Fire Headquarters
11 Church Road
Shrewsbury, MA 01545

PROJECT: TOWN OF SHREWSBURY ACCESSIBILITY PROJECT
 SHREWSBURY MAIN FIRE HEADQUARTERS
 DRAWING: FLOOR PLANS
 SCALE: 1/16" = 1'-0"
 DATE: FEBRUARY 2002

LOWER FLOOR PLAN

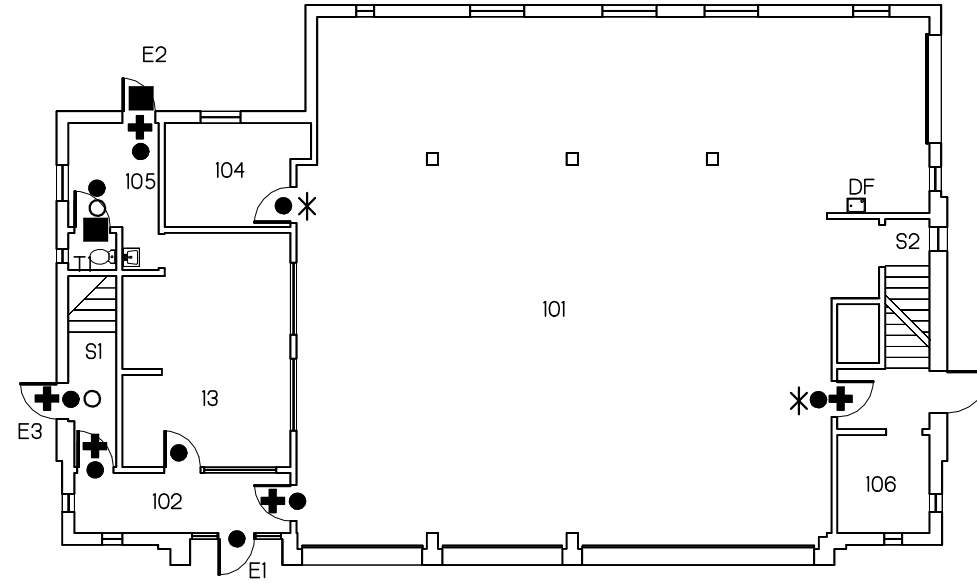
<i>Item</i>	<i>Action Required</i>	<i>Est. Cost</i>	<i>Priority</i>	<i>Feasibility</i>
Corridor 102- Magazine rack projects too far into space	Relocate rack or make shallower	200	1	1
Corridor 204 - Not accessible from lower floor	Provide either an elevator or relocate chiefs office, records office, toilet rooms and meeting room to the main level by means of an addition. See sketch.	250,000	2	3

<i>Item</i>	<i>Action Required</i>	<i>Est. Cost</i>	<i>Priority</i>	<i>Feasibility</i>
2 doors do not have 32" clear opening	Widen doors	12,000	2	3
2 doors do not have the required clearance on the pull side	Either relocate or remove doors.	4,000	2	3
2 doors do not have the required clearance on push side	Either relocate or remove doors.	2,000	2	3
9 doors do not have hardware that is operable with a closed fist.	Replace hardware.	4,000	2	2
5 doors have closers that close too fast or are too hard to operate.	Replace or adjust closers.	2,500	2	2

NOTE: All of the above items are on the lower level only as we recommend that all public functions be relocated to the lower level. See Section 05.

UPPER FLOOR PLAN

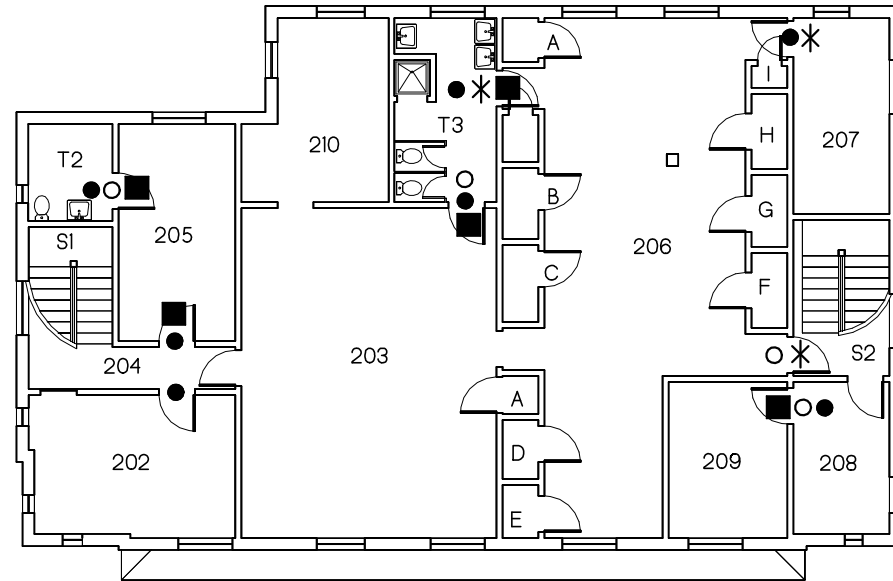
<i>Item</i>	<i>Action Required</i>	<i>Est. Cost</i>	<i>Priority</i>	<i>Feasibility</i>
Stairs A and B Handrail height incorrect both sides, incorrect shape and size, do not extend at top and bottom landings, inside rails are not continuous. Guardrail at upper landing is too low	None, we recommend that the upper floor not be made accessible to the public, but public functions be relocated to the lower level.	-	-	-

<i>Item</i>	<i>Action Required</i>	<i>Est. Cost</i>	<i>Priority</i>	<i>Feasibility</i>
Toilet 1 Not on an accessible route; No signage; Toilet is too close to the wall; Lavatory does not have knee clearance; Faucets not operable with a closed fist; Dispensers too high	None, it is recommended that a new accessible toilet room be constructed in conjunction with the new public functions on the first floor.	-	-	-
Toilets 2 and 3 Not on an accessible route; No signage; No accessible stall and shower; No 5' turning area; No knee clearance at lavatories; Faucets not operable with a closed fist; Mirrors and dispensers too high.	None, it is recommended that the upper floor is to be used by fire personnel only	-	-	-

<i>Item</i>	<i>Action Required</i>	<i>Est. Cost</i>	<i>Priority</i>	<i>Feasibility</i>
Room 206 Counter top is too high with no knee space; Oven too low; Wall cabinets too high.	None, it is recommended that the upper floor be used only by fire department personnel	-	-	-
